RECEIPT DATE: 5/5/17 **ONSITE SEWAGE DISPOSAL SYSTEM** P 560629-E

**Subject:** BAT Plan\_Tall Trees Lot 2

RE: Tall Trees Lot 2 Bat Plan  
CLSI Job No.: 2016079

ONSITE SEWAGE DISPOSAL SYSTEM DESIGN PLAN  
 LOT 2 - 5513 GREEN BRIDGE RD.  
 TAX ACCOUNT NO.: 414865  
**TALL TREES**  
 LOT 2  
 FIFTH ELECTION DISTRICT, HOWARD COUNTY, MARYLAND  
 WAR PLAT NO. 23533, TAX MAP: 27, GRID: 24, PARCEL: 26

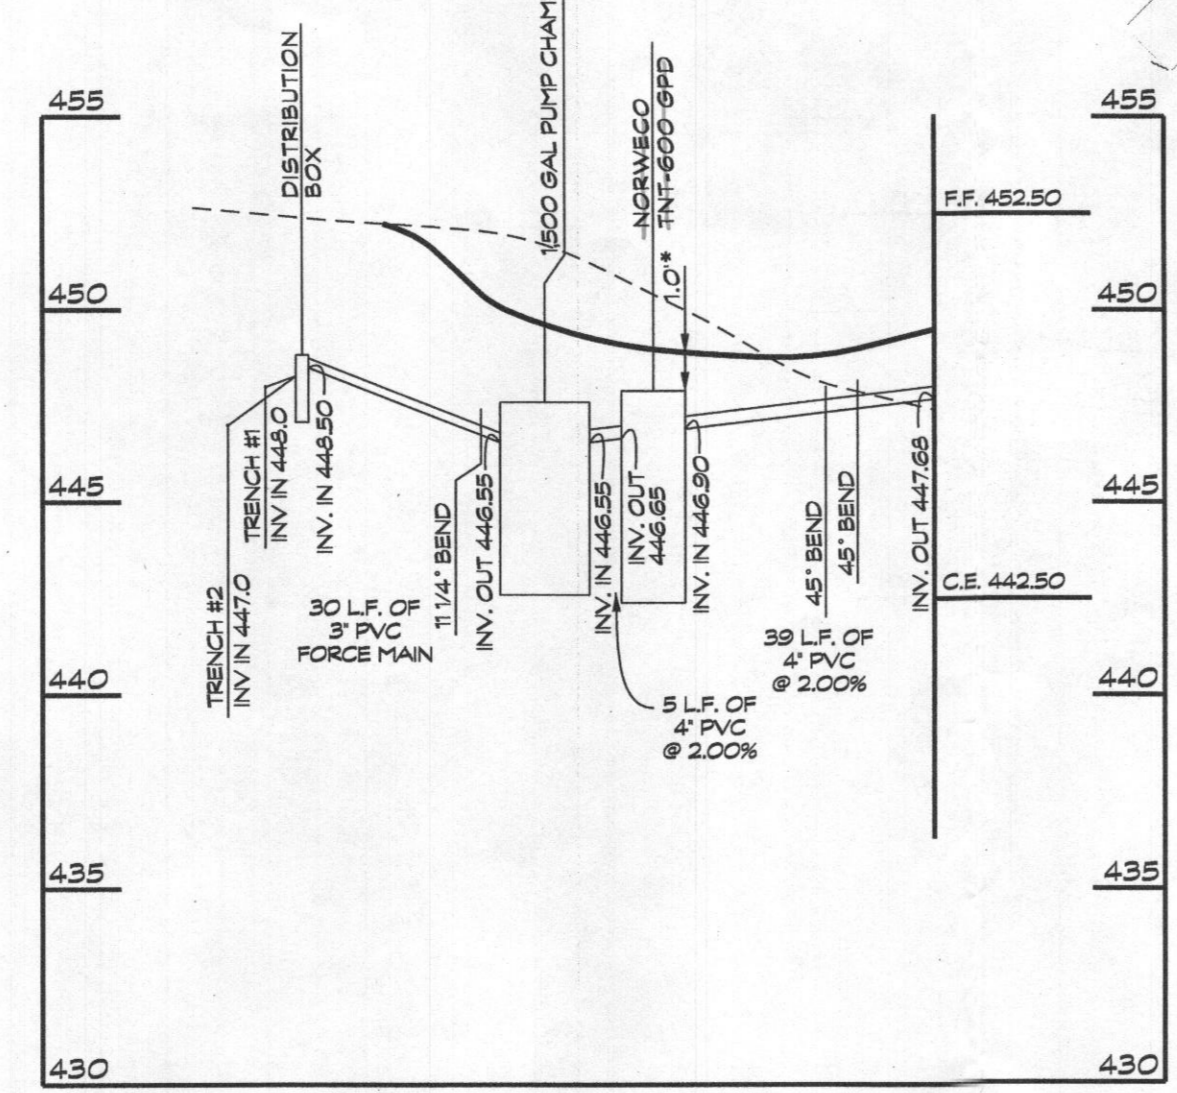
6. Trench 2 exceeds 7 feet in depth which does not align with the septic specs.

5. Where does the 30 gpm come from in the calculation and on the pump curve because the pump curve intersects at about 85 gpm with 6.01 TDH. (see attachment).  
The plan has been revised
6. Trench 2 exceeds 7 feet in depth which does not align with the septic specs.  
The trench 2 information has been revised. I was thinking about the replacement system

SEPTIC LINE PROFILE  
 SCALE: HORIZ. 1"=30' VERT. 1"=5'

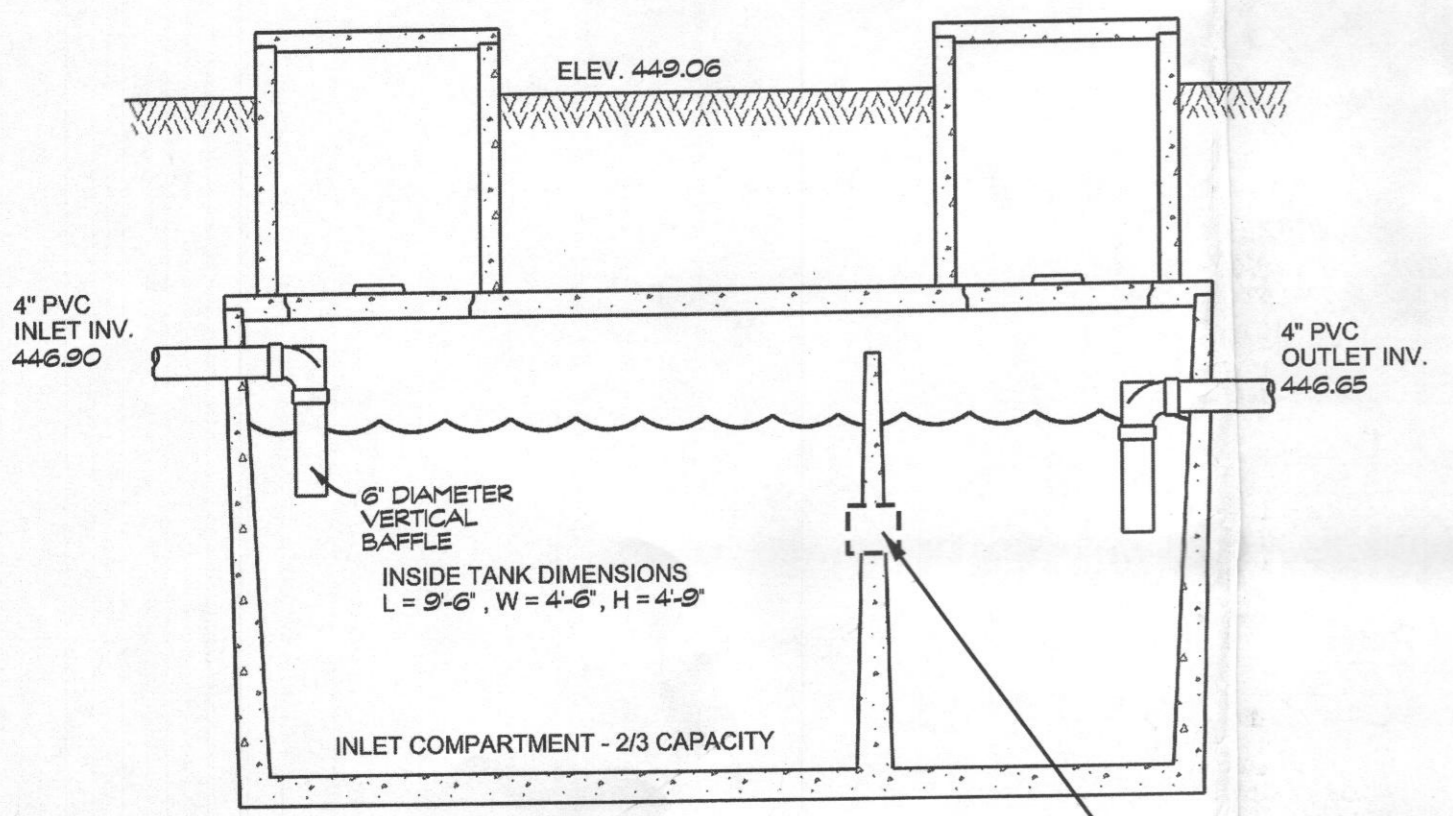
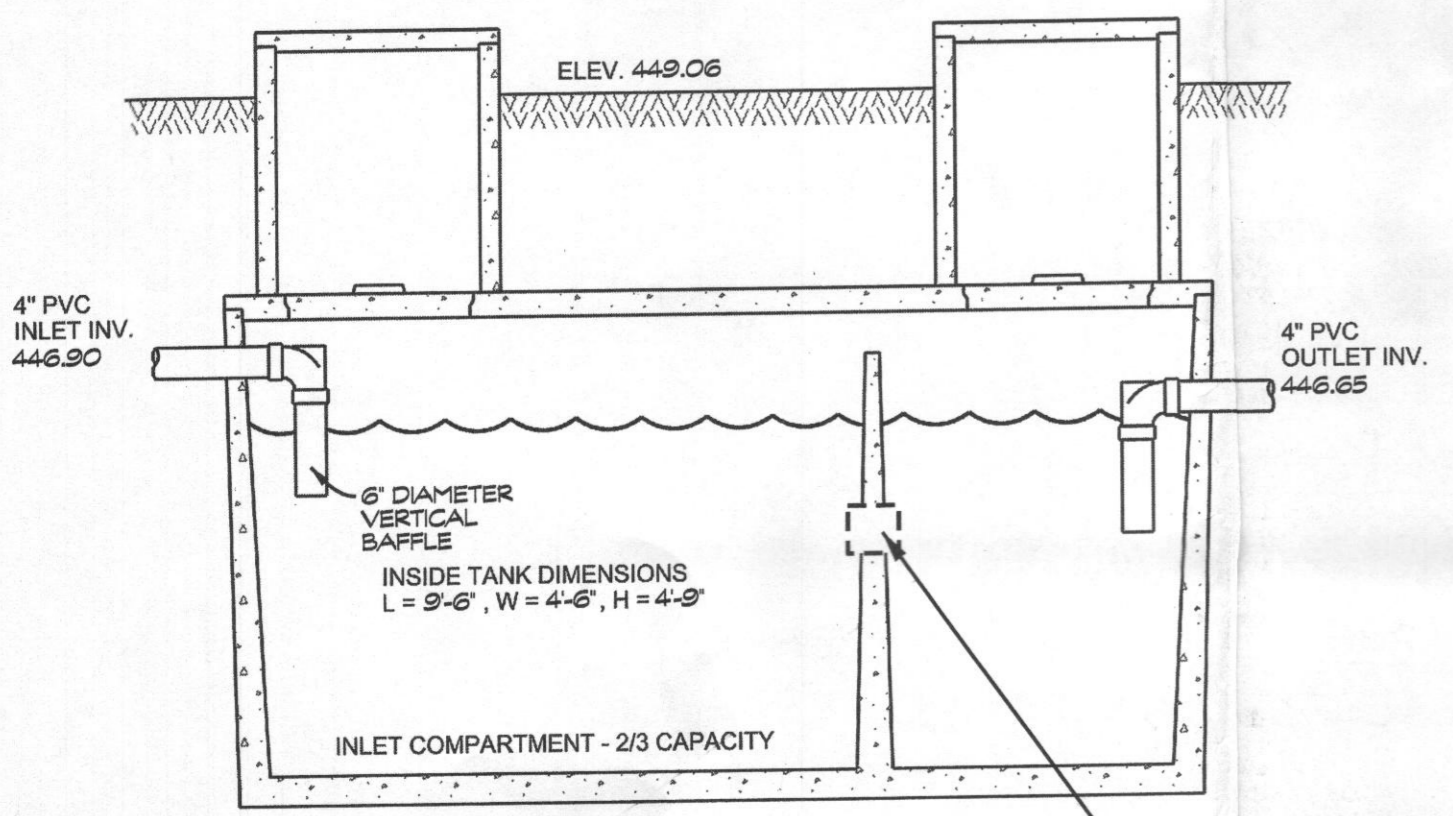
- 1.) I believe the static head on the system is  $448.50 - 443.17$  (elevation of pump off float switch per plan) = 5.33 (not 7.14). Based on a 3 inch force main (FM), the TDH is  $5.33 + 0.68 = 6.01$ . However, the first page indicates a 2 inch FM as shown in the "septic line profile". Please clarify.

2. Static Head Calculation was not shown per my comment on the 2<sup>nd</sup> page of the revised plan (See attachment).
3. The revised plan still shows the force main as a 2 inch line on 1<sup>st</sup> page of plan (See attachment)

3. The revised plan still shows the force main as a 2 inch line on 1<sup>st</sup> page of plan (See attachment) The pipe size has been revised.
4. The dimensions of the top tank profile still does not match the dimensions of the side profile on 2<sup>nd</sup> page. (See attachment) With that said, if the true dimensions are Tank L=149in, Tank W=74in, H (Above High Water Alarm) = 12.57in, then it shows enough emergency storage. Choose one manufacturer on plan.  
I have listed only one manufacturer
